Report of Robert S. Young, PhD, PG (“Young Report”)

*A Scientific Analysis of the Environmental Assessment: Nimmo Parkway Phase VII-B*

Robert S. Young, PhD, PG

**Exhibit 1**

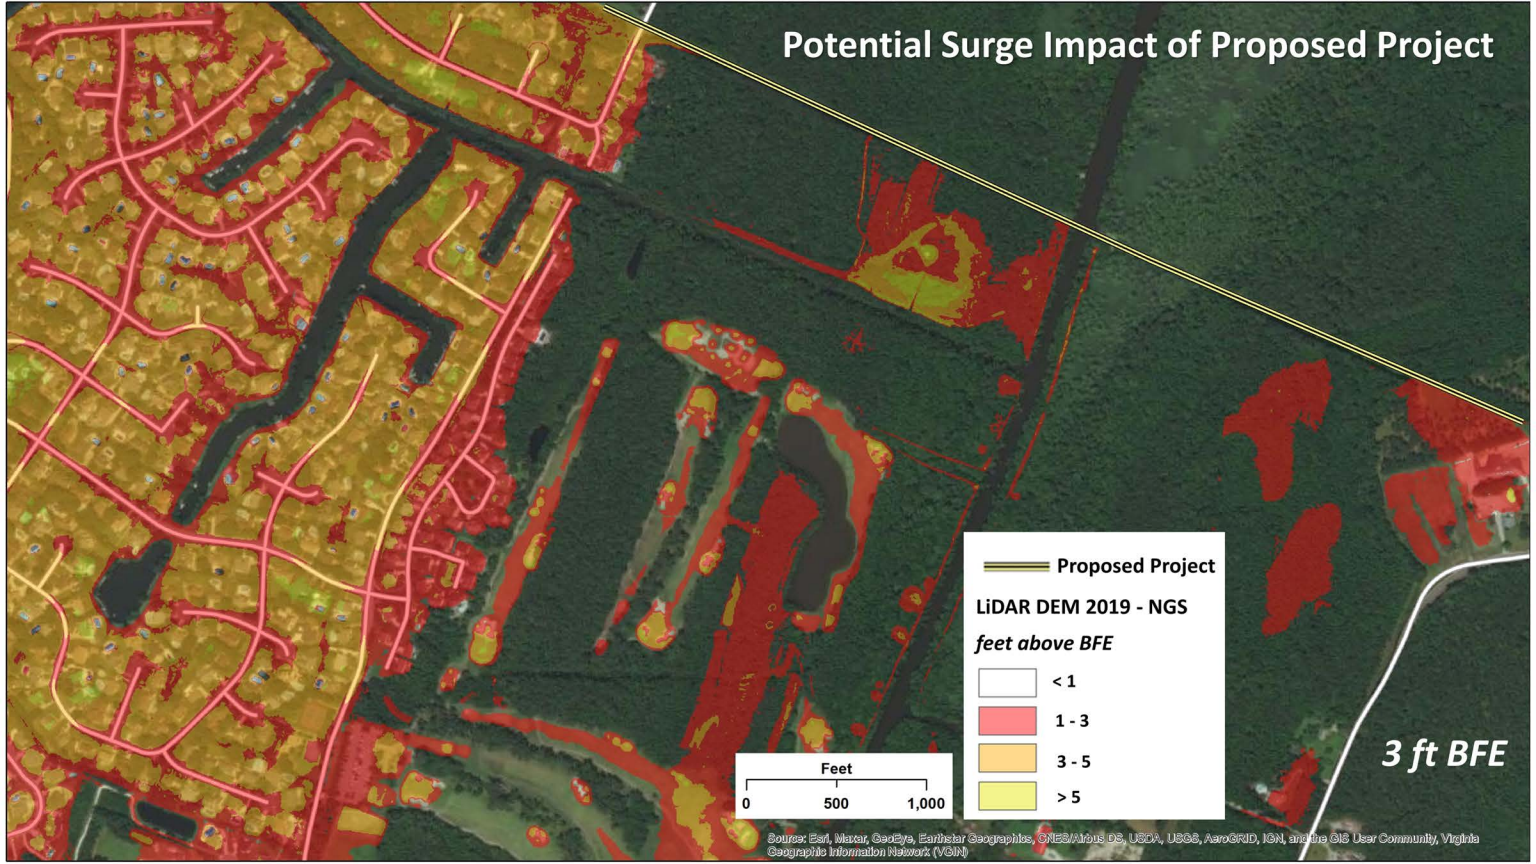
Further, the project would not need to raise the surge or wind-driven flooding by a significant amount before nearby properties would be impacted by the resulting increase in flood levels. To illustrate this point, I used a Light Detection and Radar (“LiDAR”)-derived Digital Elevation Model (NGS, 2019) to create the graphic labeled “Potential Surge Impact of Proposed Project” that I have attached to my report as Exhibit 1. This is a simple elevation-based assessment demonstrating that the Proposed Project need only have a small impact on flood water elevation to generate flooding in adjacent neighborhoods, primarily in those colored areas that are directly connected to the existing FEMA AE Zone.

The areas in Exhibit 1 that are not shown in the red, orange, or yellow shading are all, at most, 1 foot above the projected Base Flood Elevation (“BFE”) (of 3 feet), and they are therefore already vulnerable to flooding from an estimated 100-year storm. These are mostly natural, undeveloped areas that are part of the Back Bay National Wildlife Refuge.

The areas shown in red on Exhibit 1 are between 1 to 3 feet above the projected Base Flood Elevation, and the areas shown in orange are between 3 to 5 feet above the projected Base Flood Elevation. These red and orange areas largely consist of homes, neighborhoods, and other development, and they are currently not predicted to flood during a 100-year storm.

However, if the Proposed Project raised the surge from the 100-year storm by 1 to 3 feet above that current BFE, most of the areas shown in red on Exhibit 1 would now flood. If the Proposed Project raised the flood levels from 3 to 5 feet above the current BFE, most of the areas shown in orange on Exhibit 1 would now flood.

Based on the project description provided in the Draft EA, it is reasonable to anticipate that the Proposed Project would increase the surge from a moderate-sized storm by several feet, particularly in combination with the Nimmo Parkway Phase VII-A project. In summary, the Proposed Project would increase storm surge and flooding for properties to the east (in
